COUNCIL ASSESSMENT REPORT

Panel Reference	2017SSW046
DA Number	DA 422.1/2017
LGA	Fairfield City Council
Proposed Development	Newleaf Bonnyrigg Renewal Project - Stages 6a & 7 comprising Torrens Title Subdivision (to create 121 Torrens Title Lots, 2 Development lots and 4 residue lots), Construction of 161 dwellings (comprising 75 detached, 46 attached dwellings and 40 garden apartments) and associated road, landscape and public domain works.
Street Address	14A Shoemaker Place, No.'s 12 - 14 Laycock Place, No. 2 Palisade Crescent, No.'s 40, 36, 34, 32 & 42 Newleaf Parade, No.'s 2 & 4 - 17 Shoemaker Place, No.'s 1 - 4 Shearing Place, No.'s 6, 4 & 2 Wall Place, No. 12 Tarlington Parade, No.'s 3 - 9 Stubbs Place, No.'s 1 - 4 Kain Place, No.'s 1 - 2 & 4 - 14 Bean Place, Bonnyrigg
Applicant/Owner	Applicant: Urban Growth NSW C/o Urbis Owner: NSW Land and Housing Corporation
Date of DA lodgement	8 August 2017
Number of Submissions	One (1) submission

Proposal: Newleaf Bonnyrigg Renewal Project - Stages 6a & 7 comprising Torrens Title Subdivision (to create 121 Torrens Title Lots, 2 Development lots and 4 residue lots), Construction of 161 dwellings (comprising 75 detached, 46 attached dwe

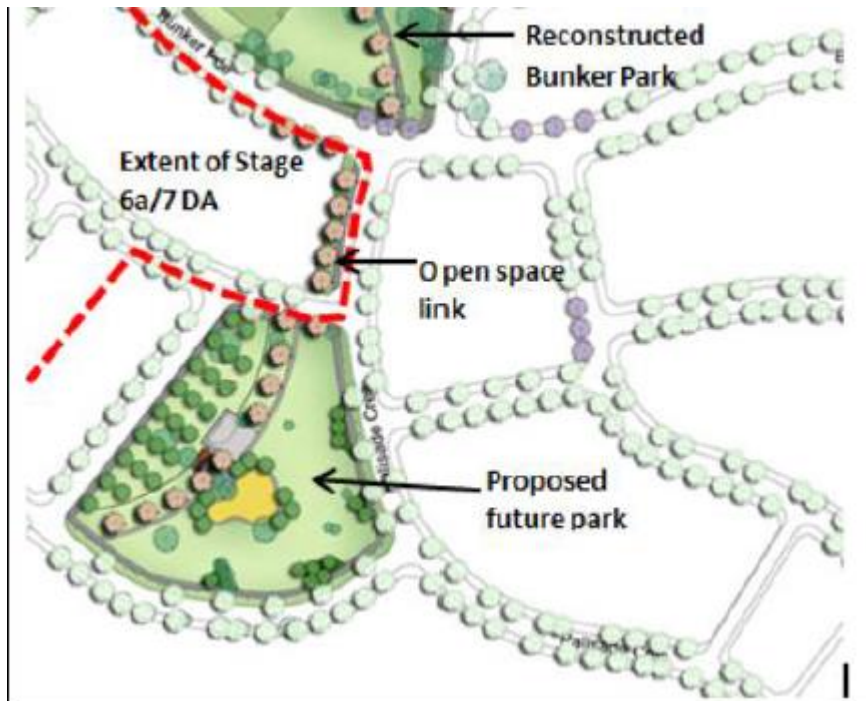
Council officers raised initial concern that the overall number of dwellings proposed across Stages 6a and 7 may be inconsistent with the expected dwelling yields identified in the 'Indicative Staging Plan – December 2011'. The applicant has provided further information including likely yields for stages 6b and 6c which are not the subject of this application.

It is noted that in Stages 1 - 5, 554 dwellings have been approved compared to the 593 dwellings in the Staging Plan (39 dwellings below). Under Stages 6 and 7, 255 dwellings are to be provided in the Staging Plan. The proposal seeks a total of 161 dwellings however stages 6b and 6c are not included. The applicant has stipulated that 6b will provide 24 dwellings and 6c will provide 31 dwellings. Accordingly, it is likely that Stages 6a, 6b, 6c and 7 will provide 216 dwellings (a shortfall of 39 dwellings).

Accordingly, Stages 1 to 7 has a total of 770 dwellings approved/constructed/proposed and the Indicative Staging Plan seeks 848 dwellings to be provided. Accordingly, there is a shortfall of 78 dwellings which represents approximately 9.2% of the required yield.

While the concept plan is indicative, concerns in relation to the shortfall of dwellings is compounded by the release of SEARs from the Department in regards to a further Section 75W Modification to the Concept Approval which seeks to increase the density of the estate by a further 500 dwellings. Notwithstanding this, no application has been submitted and cannot be taken into consideration as part of this assessment. Accordingly, any amendment to the Concept Plan in relation to additional yields needs to address/consider the shortfall in dwellings across the first 7 stages.

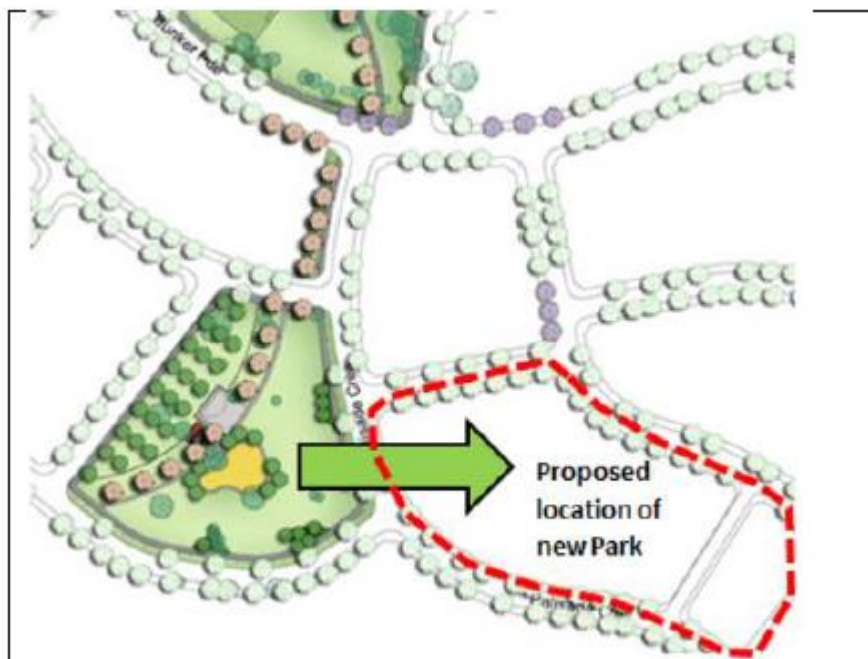
The subject application does not provide Connector Park (along Palisade Crescent) between Junior Play Park and Hilltop Park. The applicant has indicated that the purpose of Connector Park was to provide an 'urban design' link between the recently constructed Hilltop Park, to Junior Play Park located in the south west corner of the Newleaf estate as shown below.

In July 2015, consultation between the applicant and Council occurred in relation to the relocation of Junior Play Park further to the east toward Humphries Road. On 28 July 2017, Council at its Ordinary Meeting gave in principal support to its relocation (as seen in the diagram below). The purpose of the relocation was to provide a more appropriate drainage solution for the site's eastern catchment in relation to on-site detention that helps to avoid significant downstream impacts from the development. Accordingly, the purpose of Connector Park is no longer relevant given that it cannot provide a link between the two parks.

Details of the removal of the Connector Park was considered at Council's Ordinary meeting on 12 December 2017, and Fairfield City Council raised no objection to the construction of dwellings located on Connector Park given that the area of open space

will be offset in future stages and will not result in a net loss of open space within Newleaf Bonnyrigg estate.

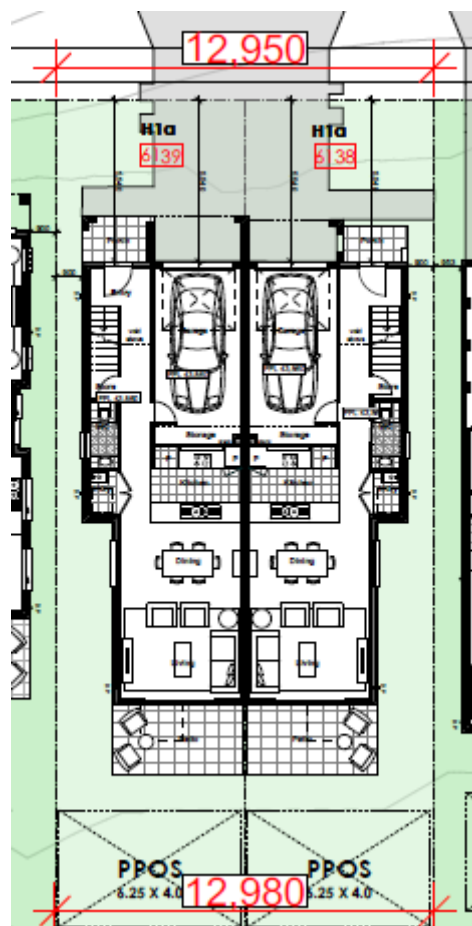
The Masterplan provides Lot Dimensions that the proposed dwellings are to comply with. The applicant was advised that the following lots do not comply:

- Lots 6148, 6118, 6119, 6202, 6203, 6131 are irregular in nature and taper down towards the frontage. Accordingly, the average lot width generally complies with the numerical standard or the variation sought is considered relatively minor. Accordingly, the variations sought on these lots would not warrant the refusal of the application.

- The variations sought for Lots 6134, 6111, 6112, 6222, 6223 are minor in nature and range from 590mm to 2036mm (all within 10%). The dwellings meet all the other provisions including private open space and setbacks and provide suitable internal solar access. Accordingly, the variations would not warrant the refusal of the application.
